B 1 **29387**SEQUENCE NO.
(MDE USE ONLY)STATE OF MARYLAND
APPLICATION FOR PERMIT TO DRILL WELL

RE: Replacement Well Sampling & Abandonment

RE: Emergency Replacement Well- 15936 Frederick Road
Lisbon MD 21765

SITE INSPECTION SHEET

LOCATION DIAGRAM

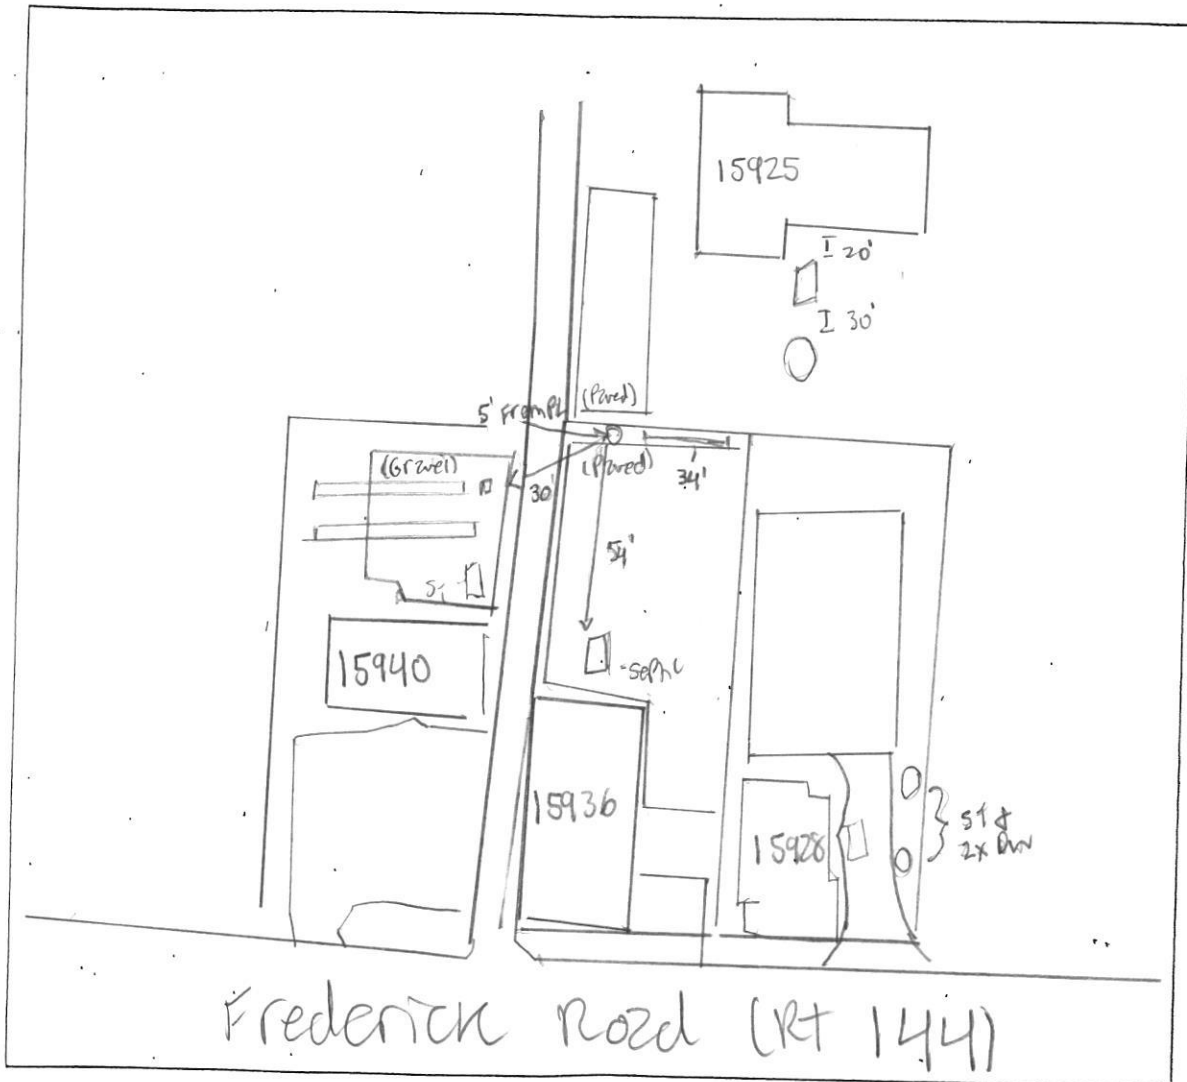
15936 Frederick Rd
 3/25/26 - driller completed
 well @ 200' - sediment fence
 wasn't adequate so there was
 some discharge onto a
 neighboring property.

COMMENTS: Met onsite w/ Homeowner, Christina Perfeter, & Driller,
Andy Houseman. Ex well is running dry, very shallow & ~ 20' from St.
Driller stated well white onsite, ~ 54' from prop St, 30' from 15940
Frederick Rd septic, 5' from Pl, & unable to confirm distance to
15928 Frederick Rd septic. Prop septic pile not found. (SP)
DATE: 11/19/2025 INSPECTOR: S. Page

proposed well is:
5' from PL
30' from road
65' from foundation

19/2026-
rell site
approved
SP

Diagram of septic:

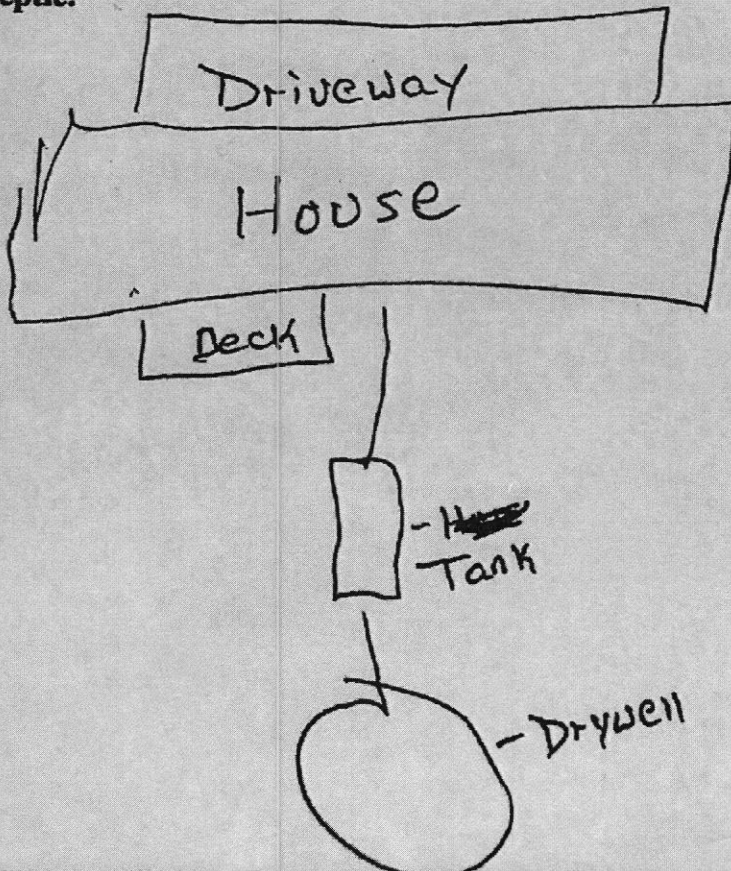
15925 Frederick Rd
for inspection report
Received from
Countywide Septic. (SP)

FIELD NOTES: Probed into stone and came up dry.
System is working properly
